S-SB-0032-12 Rev1 November 19, 2012

MIL "ON" DTC P0017 or P0019

Service Category Engine/Hybrid System

Section Engine Control

Figure 1.

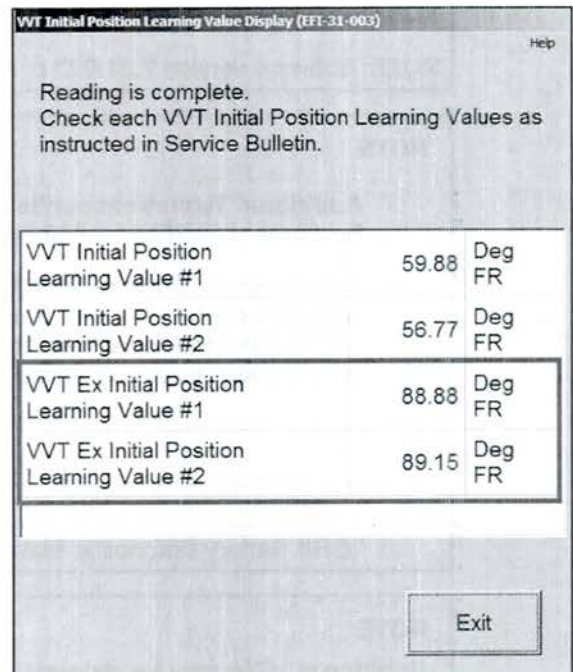
1. Confirm DTC P0017 or P0019 is set.
2. Using the Techstream Utility "VVT Initial Position Learning Value Display", confirm the VVT Ex Initial Position Learning Value #1 and #2 are within the range.

RANGE (IN DEGREES)	
	MINIMUM	MAXIMUM
VVT Ex Initial Position Learning Value	85.0	95.0

- **YES** — Proceed to step 4 (Reprogram the ECM).
- **NO** — Proceed to step 5 (Replace the ECM).

Figure 2. Location of Authorized Modifications Label on 2013 FR-S

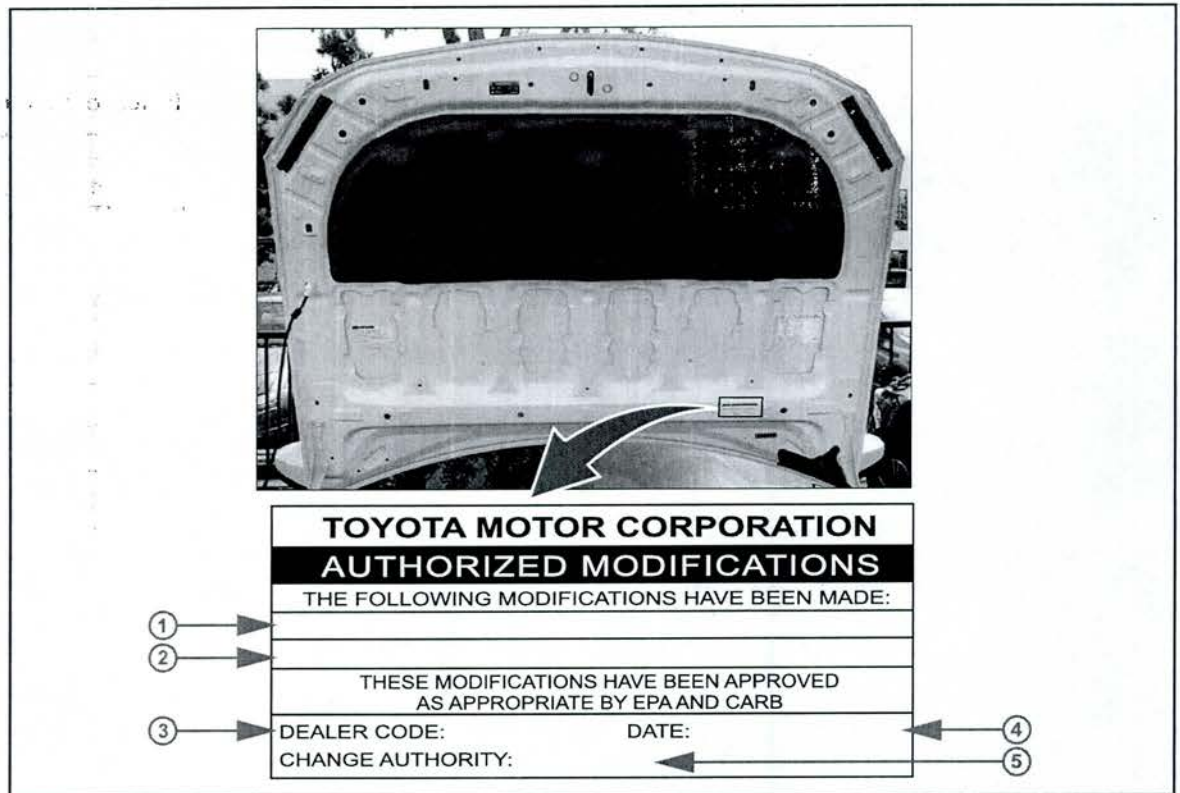
- A. Check for the Authorized Modifications Label affixed to the vehicle in the location shown in Figure 2. Confirm if the ECM (PCM) calibration has been updated. If the calibration ID listed is NOT the latest ECM (PCM) calibration — go to step 4.B.

(2) Affix the Authorized Modifications Label to the vehicle at the location shown in Figure 2. The Authorized Modifications Label is available through the MDC, P/N 00451-00001-LBL.
